CHANGES AND ADDITIONS  
BULLETIN NO. 1094 (ISSUE 2)  
PARTS - TYPE BAR PAGE PRINTER (MODEL 15)

This correction sheet covers ordering information for Model 15 printer holding magnet selector parts, particularly the 95380 set of parts for converting a Model 15 printer with pulling magnets to one with holding magnets. This set of parts consists of the following:

95379 SELECTOR UNIT (ASSEM.) - HOLDING MAGNET

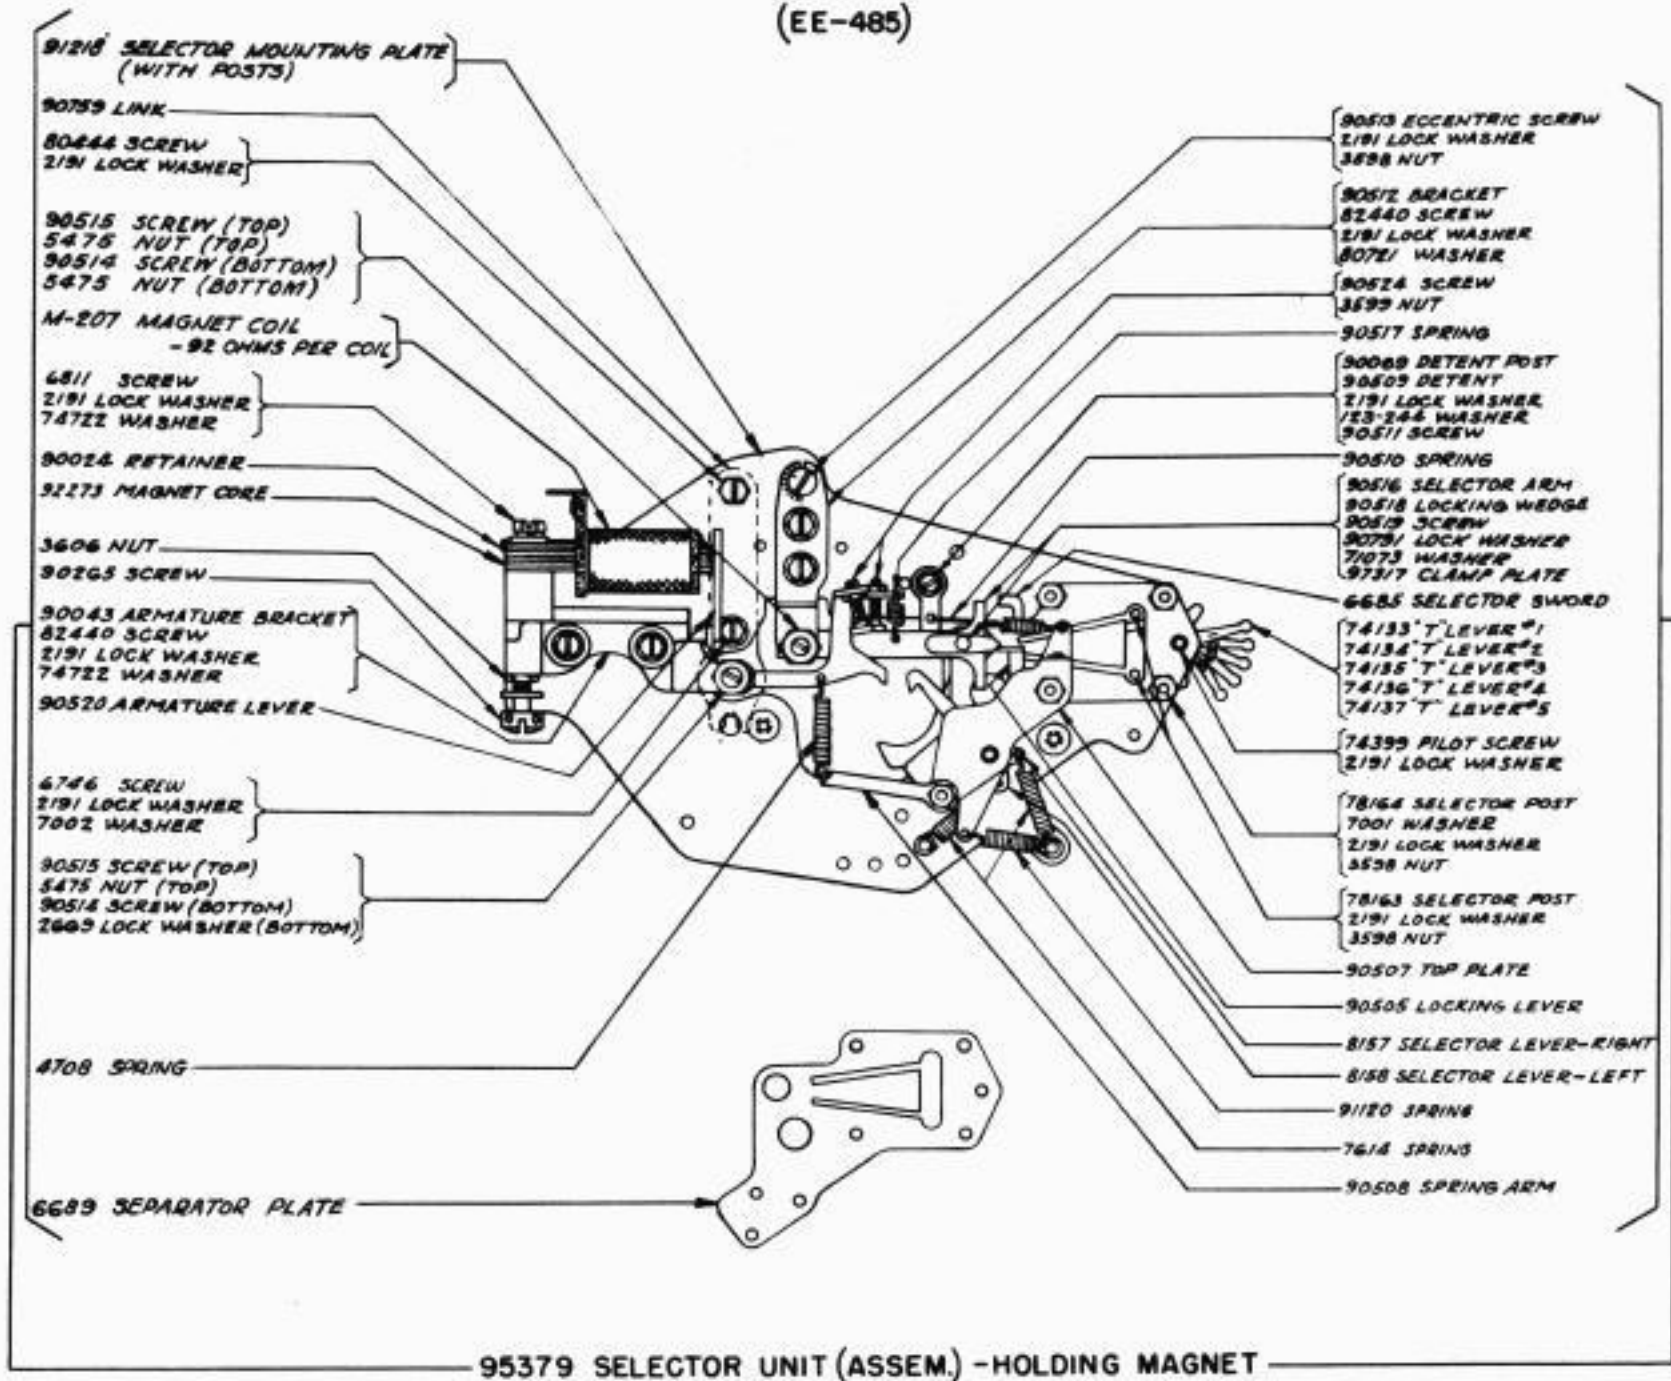
- 1 - 91265 Cam Sleeve (Assem.) - Replaces 8507 Cam Sleeve on page 3.
  - 1 - 91266 Retaining Disc - Replaces 72516 Retaining Disc on page 3.
  - 1 - 95379 Selector Unit (Assem.) - Holding Magnet
  - 1 - 90760 Range Scale (Assem.)
  - 1 - 94490 Series - Parallel Switch Bracket (Assem.)
- } Replaces Selector Unit and Range Scale on page 9. See following illustrations for component parts.
- 1 - 91278 Patent Name Plate
  - 4 - 75646 Drive Screws (For 91278)
  - 1 - 91898 Cable (For Selector magnets)
  - 1 - 95218 Lacing Twine
